DOCUMENT - 2024-346P

**Construction of the Dockstader Peel Region Paramedic Services
Reporting Station**

ADDENDUM 3

Section Detail - Stair B, D, E Typical Guard and Handrail 7
1:2 A703

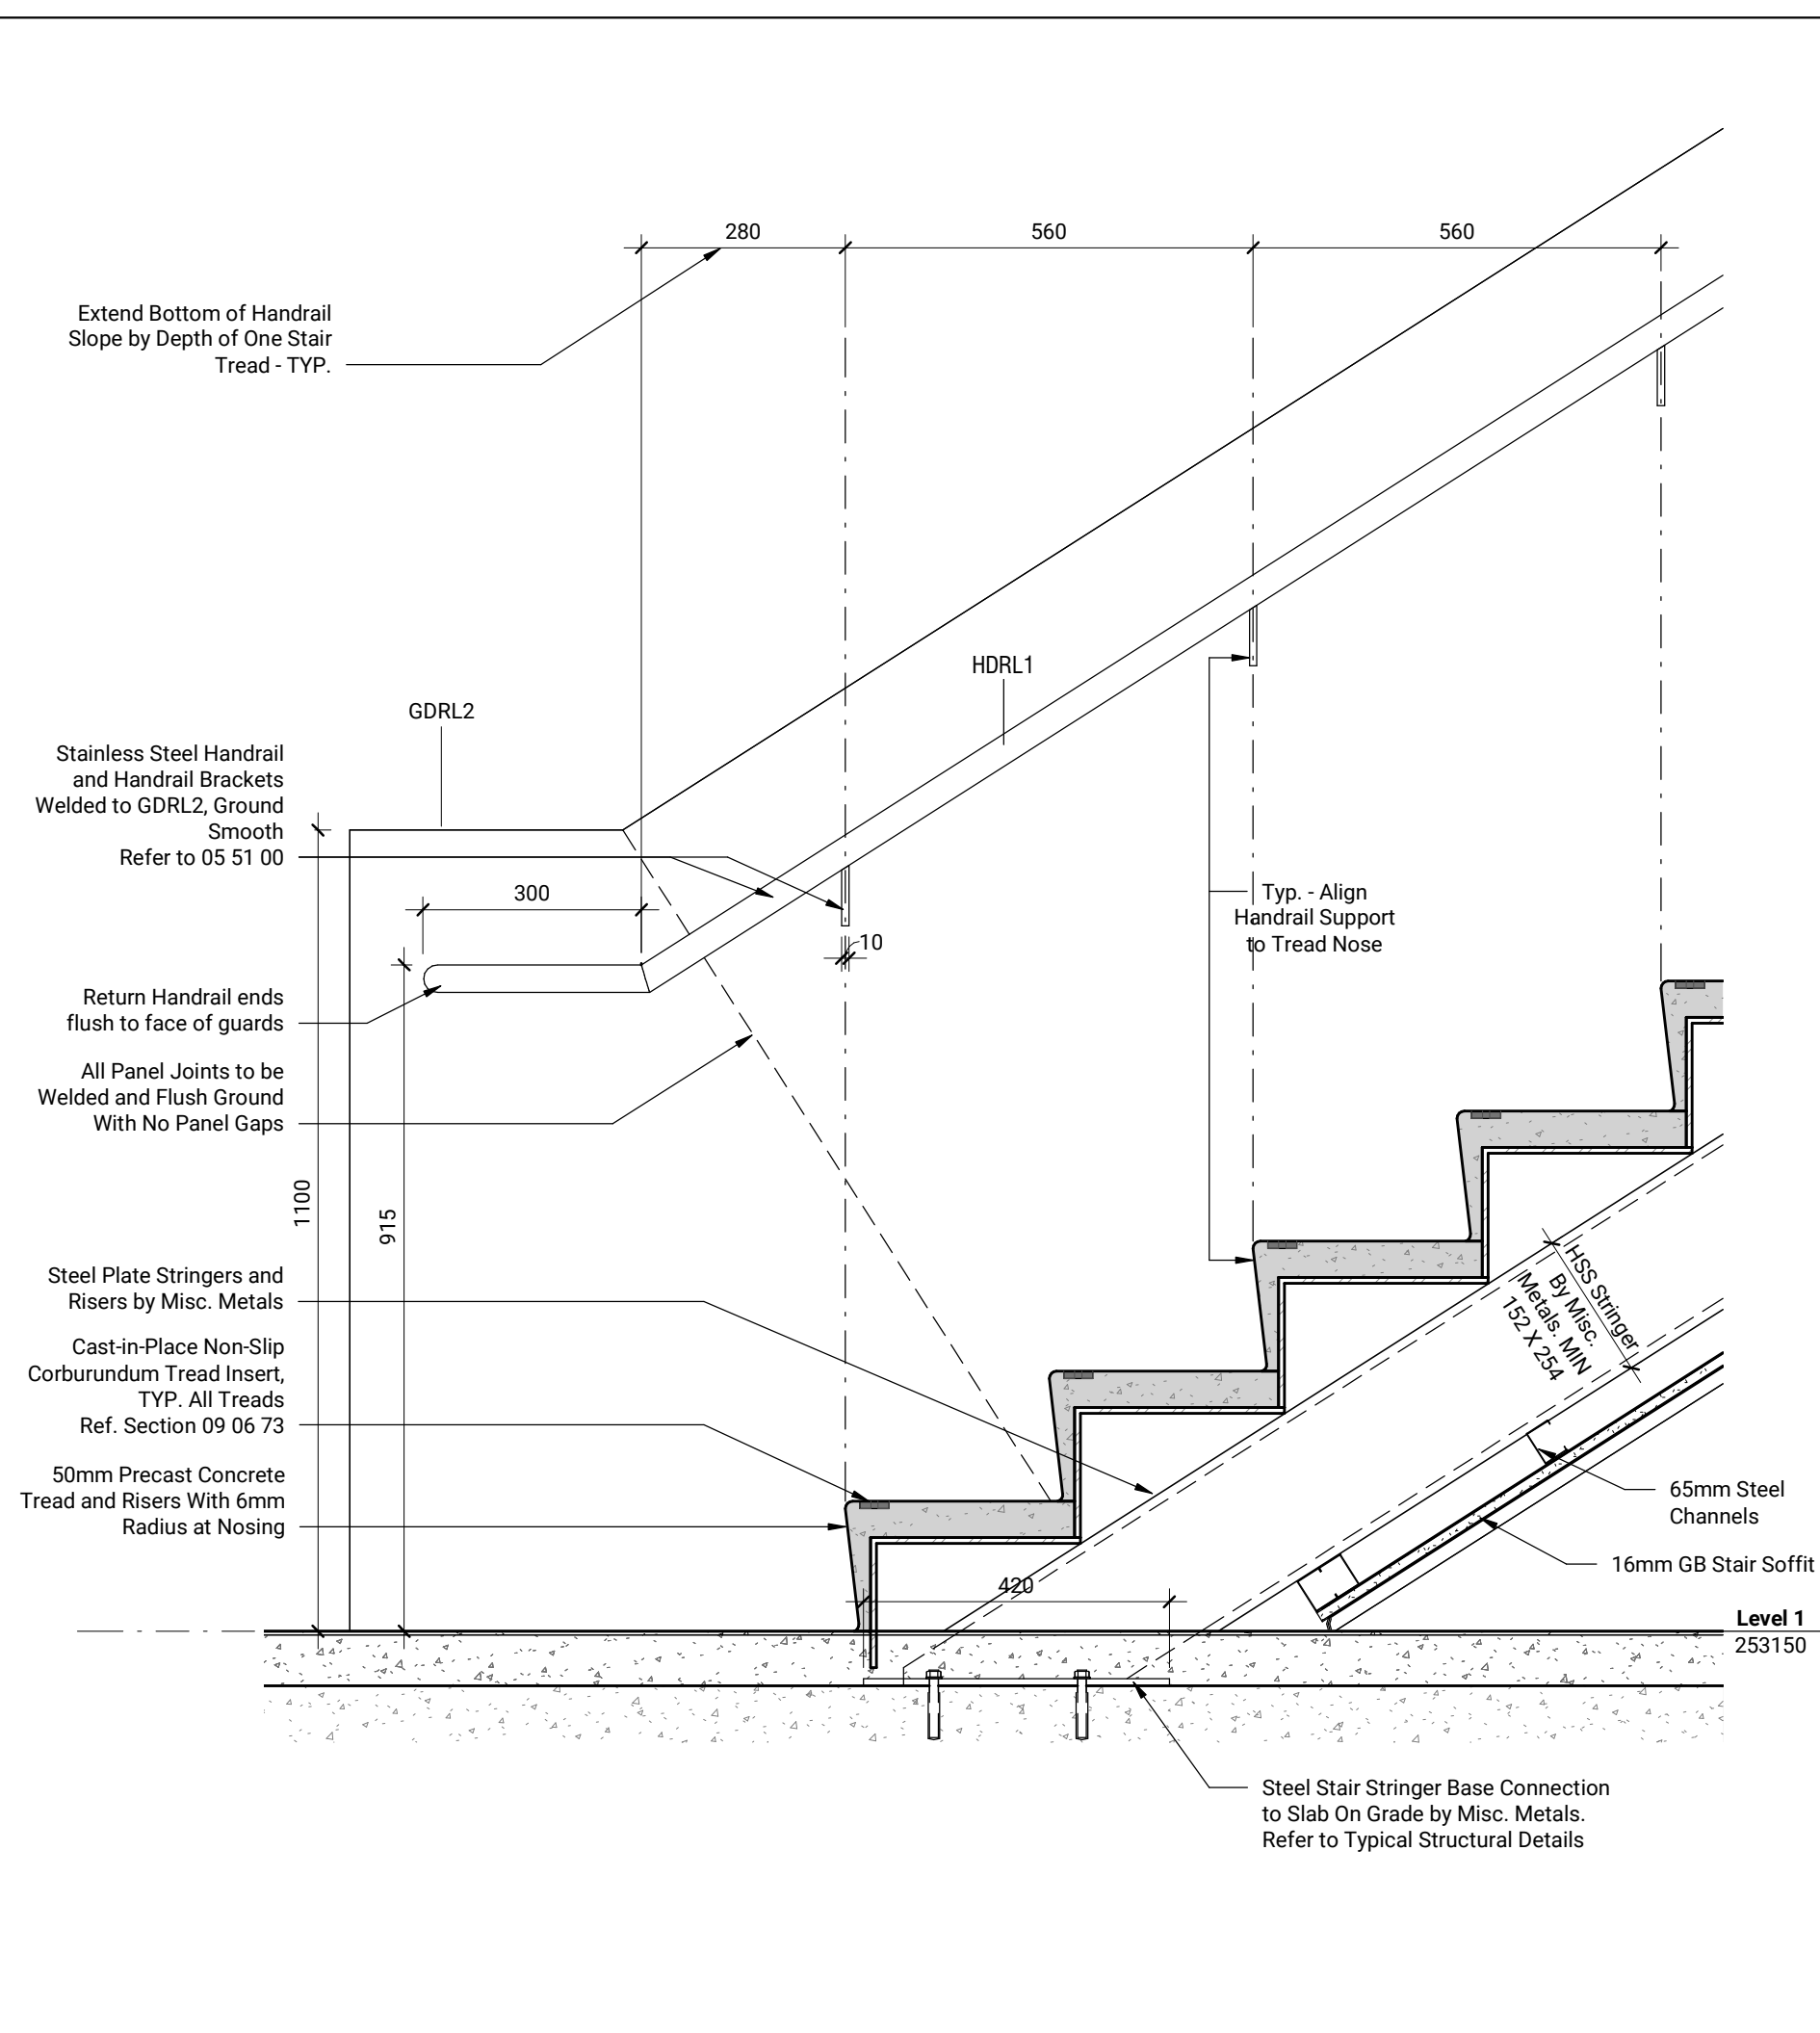
Referencing 7/A703, mentioned to check structural drawings for stringer detail for stair B.,D & E. Structural drawing is not provided any information on this. Please advise.

Please refer to revised detail 7 on drawing A703 issued as part of Tender Addendum No. 3.
